CITY PLANNING COMMISSION

- APPLICATION:**
- A. Negative Declaration
 - B. Tentative Map (P85-140.Ch. 40)
 - C. Special Permit for townhouse development of six units (Sec. 2-B-4)
 - D. Subdivision Modification to waive standard cul-de-sac improvements

LOCATION: 1140 Larkin Way

APPLC. NO. P85-140

SITE PLAN

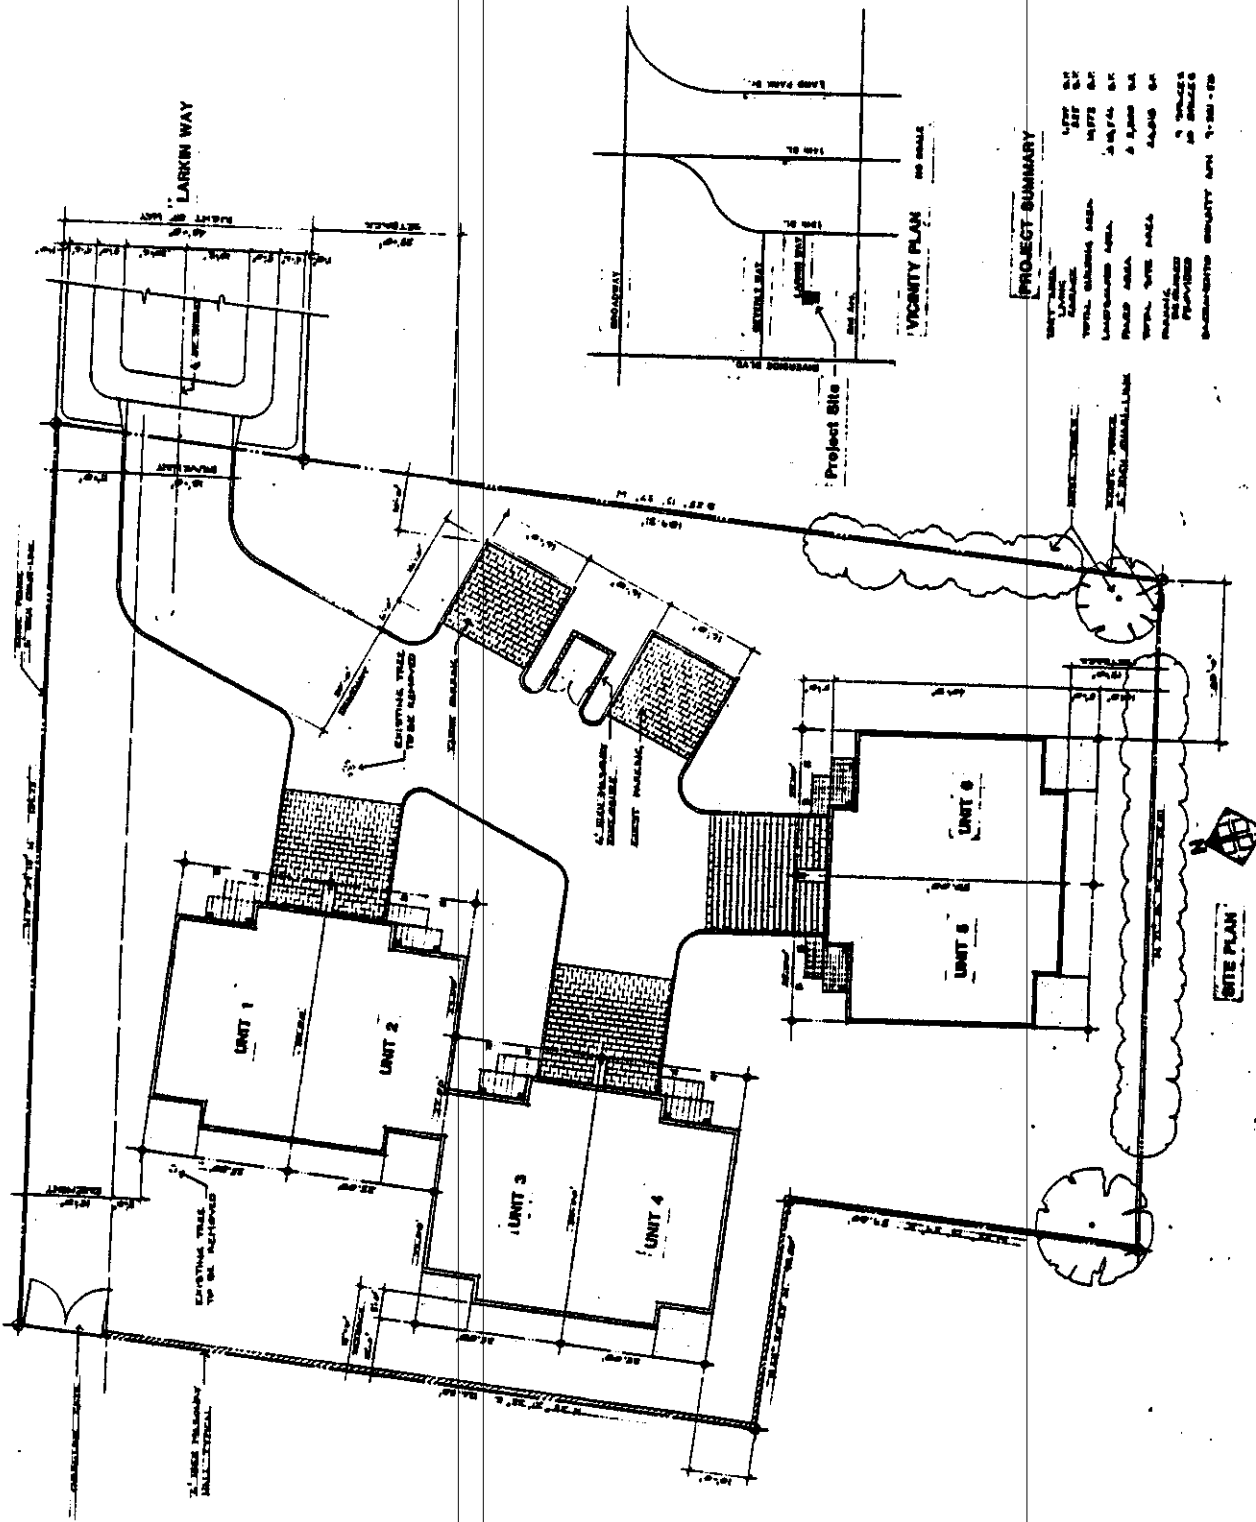
2. The applicant has resubmitted the previously approved plans which included a Subdivision Modification to waive standard cul-de-sac improvements. This design was suggested by the Commission during hearings on the request. At that time, the Fire Department indicated this design would be functional, if not preferable, for emergency equipment access. Traffic Engineering indicated a preference for the standard cul-de-sac, but submitted suggestions for an acceptable transition from Larkin Way to the subject site (See Exhibit E). No comments were received from those departments regarding the current request. Staff supports the Subdivision Modification for the following reasons:

4. The applicant proposes interlocking paving stones adjacent to garage fronts and in guest parking areas. The Design Review Board suggested a pressed in surface treatment for concrete to match the pavers.

5. Trash enclosures are not compatible with multi-family design criteria. Trash enclosures shall be designed according to Exhibit D prior to building permit approval.

6. Right-of-way for a cul-de-sac was dedicated when the previous lot line adjustment was recorded. The current design makes this right-of-way unnecessary. This is to be abandoned with recordation of the map.

7. In order to buffer the subject project from adjacent commercial uses, the applicant will be responsible for a 6 foot masonry wall long those property lines common to commercial development.

8. The applicant has identified two trees on the site which are to be retained. The map has been conditioned to assure the healthy condition of these trees during and after construction.

3. No grading shall occur within the dripline of the two trees identified for retention, and no action shall be taken that will harm the health, vitality or longevity of the trees. This conditions shall be complied with to the satisfaction of the City Arborist and/or City Planning Director.

5. Applicant shall abandon unused right-of-way within existing cul-de-sac right-of-way.

1. Applicant shall construct a 6 foot decorative masonry wall along property lines common with commercial uses. Said wall shall have a solid gate at the point of the existing easement along the western property line. Design of the wall shall be approved by the Planning Director prior to issuance of building permits.
2. Trash enclosure shall be redesigned to comply with Exhibit D.
3. Building plans shall be as approved on Exhibit C.
4. If interlocking paving stones are utilized in the parking area, a press in concrete surface shall also be utilized.

EXHIBIT C FLOOR PLANS ELEVATIONS

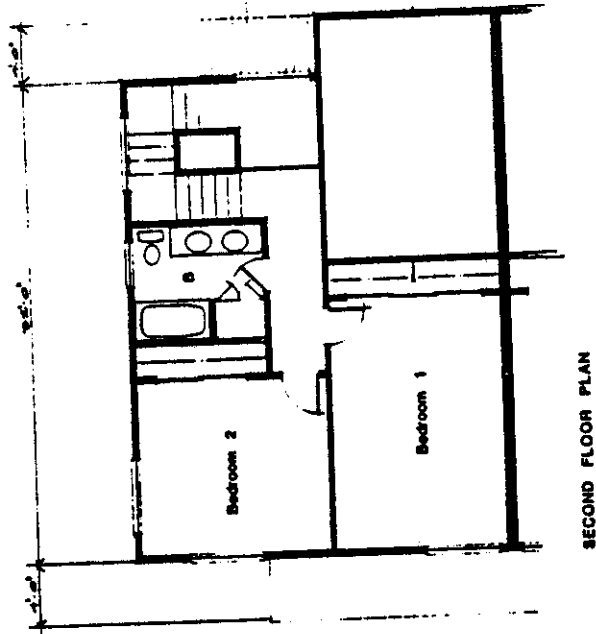
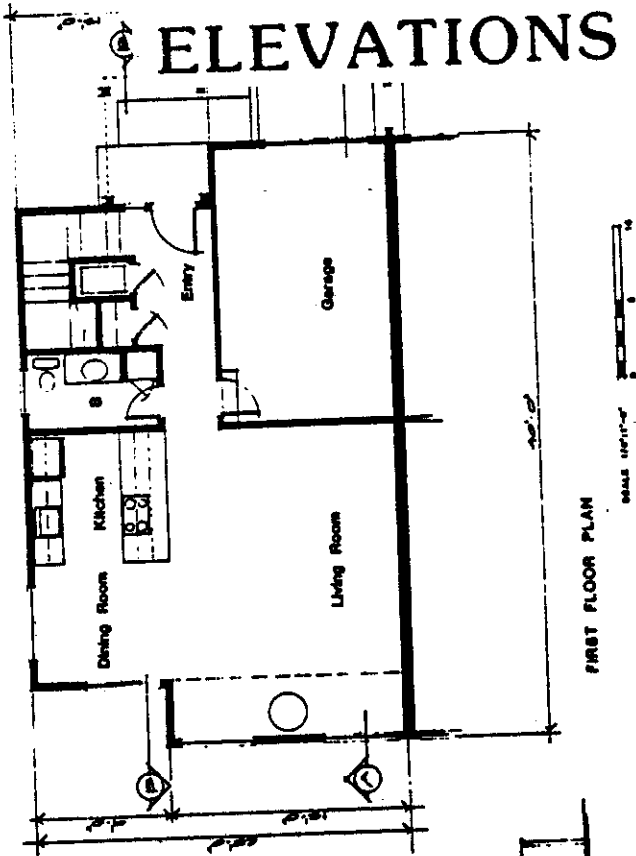
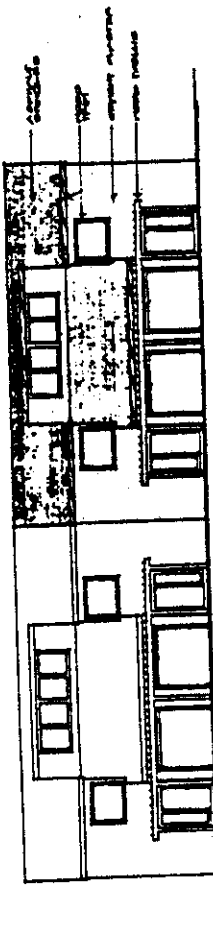
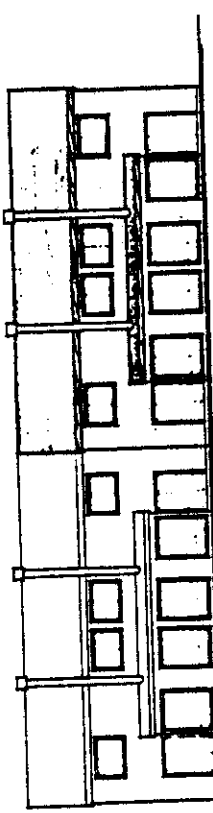
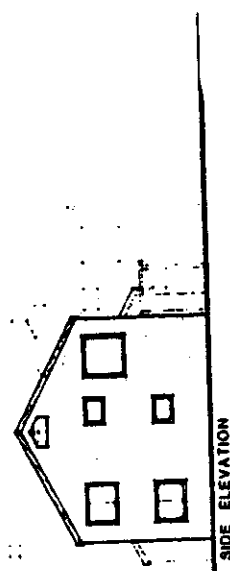
3. The applicant is proposing 6 townhouse units with 10 on-site parking spaces. This is adequate for resident and guest parking. The applicant proposes stucco siding, wood trim, anodized bronze aluminum window frames and asphalt shingle roofing material. The Design Review Board originally reviewed these elevations and determined the design and materials to be compatible with the surrounding residential neighborhood.
